Date: 29 October 2018

Report No: DPE-HUME-2018-2

From: Dr Ismet Canbulat

RE: Response to “Responses to reviews of the Hume Coal Project by Galvin and Associates, and Professor Ismet Canbulat”

Figure 1. Correct panel layout used to produce Figures 18 to 22

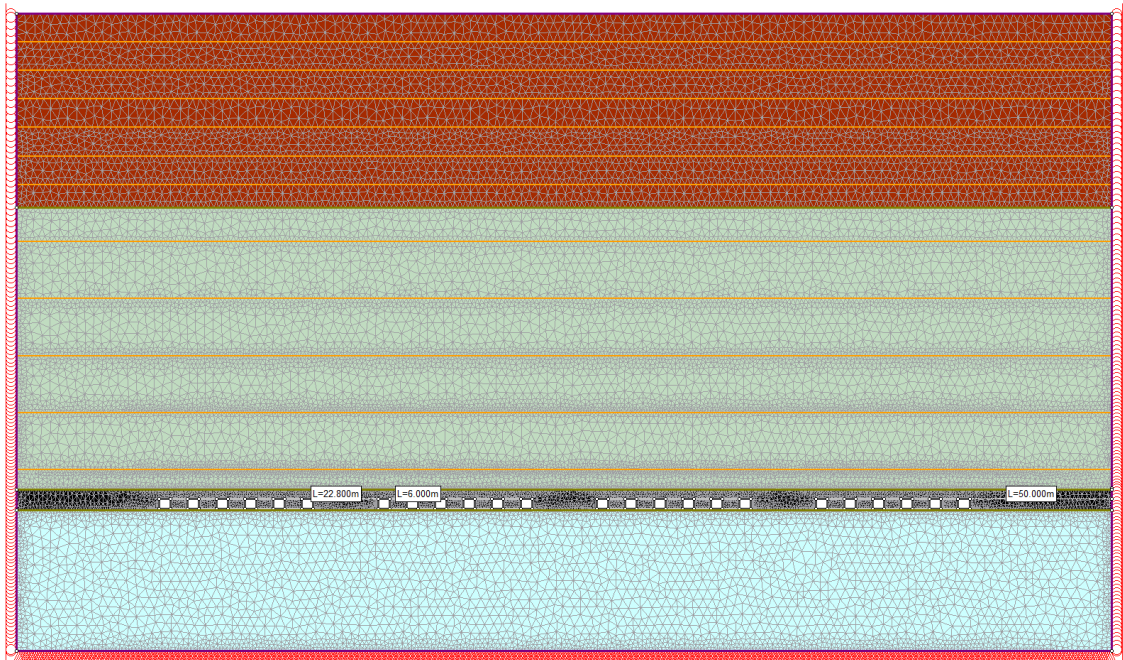
- **Anomalous results:** The title of the x-axis in Figure 21 should be distance along surface, which was correctly interpreted by Hume Coal. However, the interpretation of the results presented in Figures 21 and 22 are not

correct. This is due to the erroneous statement made in my previous report that the modelled layout was as shown in Figure 13. All layouts in Figures 19 to Figures 24 in my previous report contained 50m wide barrier pillars on either side with symmetrical boundaries (i.e., 100m wide barrier pillars) to isolate the four modelled panels. The extraction sequence was only same as provided in Figure 13. The web-pillar panel dimensions varied for different depths (as presented in Table 8), as stated in my previous report. The panels were mined in subsequent mining steps, resulting in non-symmetrical subsidence profiles in earlier panels which become symmetrical when the final, 4th panel is extracted. The purpose of these models was to demonstrate that in the case of web-pillars going into an inelastic state, the subsidence will increase as the number of panels increased. The modelled layout is shown in Figure 1 below. This should resolve most of the questions raised by Hume Coal in this section.

- I erroneously stated in my previous report that the modelled layout is as shown in Figure 13. All layouts in Figures 19 to Figures 24 in my previous report contained 50m wide barrier pillars on either side with symmetrical boundaries (i.e., 100m wide barrier pillars) to isolate the modelled four panels. This resulted in a misinterpretation of the results. Aside from this, most of Hume Coal comments have been addressed above. However, should there be any further inquiries relating to my responses, I am prepared to address them in due course.
